SPARTAN CHASSIS, INC.

CSB07-570-001

CAMPAIGN SERVICE BULLETIN

SUBJECT: Communications system-Climate Control

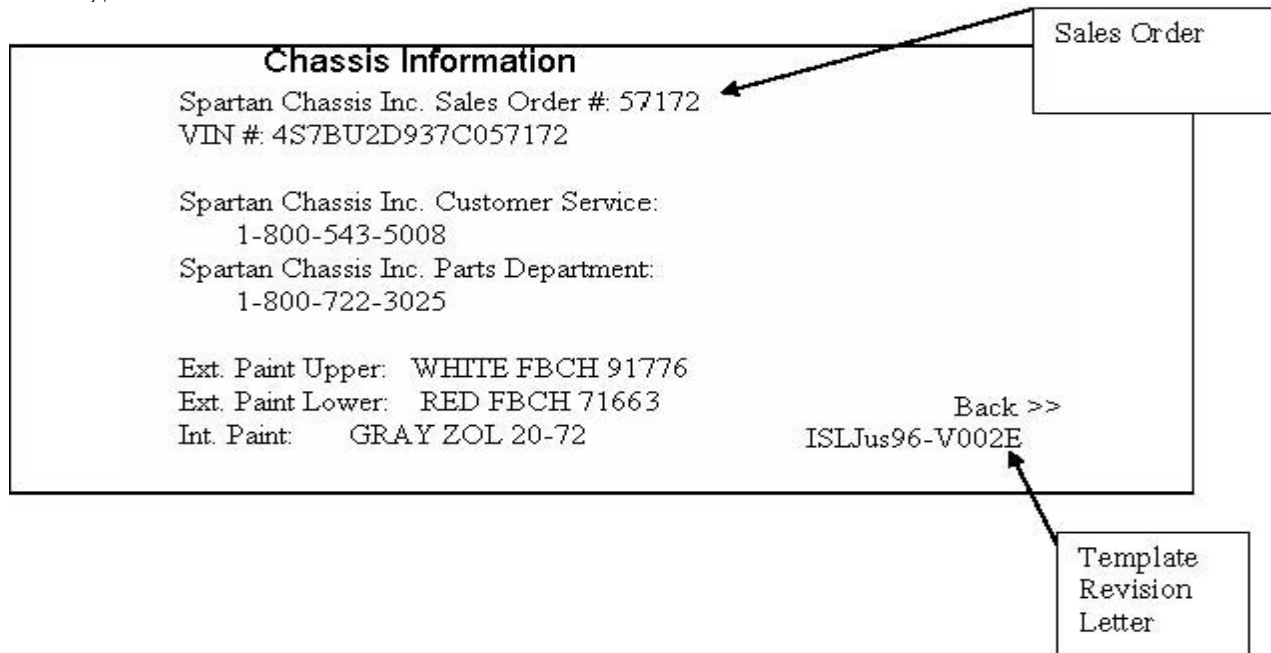
3. Connect PC (with V-Mux Downloader Software Version 6.06 or above) to the V-Mux diagnostic/programming port.
4. Open downloader and verify Node OS file version 2.04 is selected for Vista.
5. Select appropriate Vista “.bin” files and check the box to reprogram node operating (full download). Cycle vehicle power to reset system and repeat download procedure with respective file for any additional installed Vista’s.
6. Once download(s) are complete, verify using the following steps:
 - 6a. Power up chassis and press Vista display screen System Info Button.
 - 6b. Press Chassis Info Button.
 - 6c. Verify that the Chassis S.O. Number is correct and the template revision text in the lower right corner ends with an “E”.
